Comment [e1]: These changes proposed to section 6.3.2, starting p. 66, line 24.

Figure 41: Estimated usable SSMF spectrum (20 km) without DC

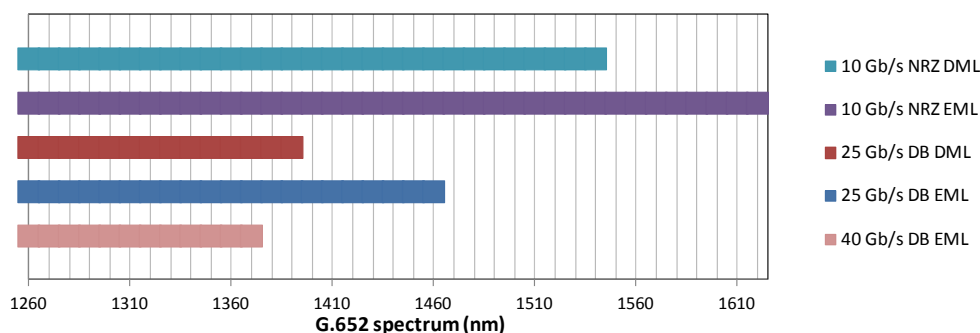
~~The (estimated) Based on simulation, the~~ usable spectrum for a 20 km G.652 standard single-mode fiber (SSMF) ~~fiber~~ that can be used without DC for the considered bit rates, laser sources and encoding are summarized in Figure 41 ~~(assuming 1 dB optical dispersion penalty).~~

Comment [e2]: Makes more sense to move this text and the figure to precede the discussion.

Comment [e3]: Updated version of Figure 41.

- If both upstream and downstream transmission is in the O-band, no DC is required. Duobinary transmission up to 25 Gb/s can be achieved with DML lasers, and 40 Gb/s with EML lasers. Co-existence with 10G-EPON, GPON and 1G-EPON simultaneously is possible, if 1G-EPON upstream transmission is constrained to the same 1310 ± 20 nm window as GPON, using a DFB laser.

- 25 Gb/s duobinary transmission in the S, C, and L-bands: Allowing for a 2 dB optical penalty (instead of 1 dB), the following can be achieved without DC: (1) 20 km up to 1560 nm, and (2) at 1600 nm, up to 18 km.

- 40 Gb/s duobinary transmission in the S, C, and L-bands: above the O-band requires DC. For ODNs longer than 5 km, DC will be required for wavelengths up to 1600 nm.
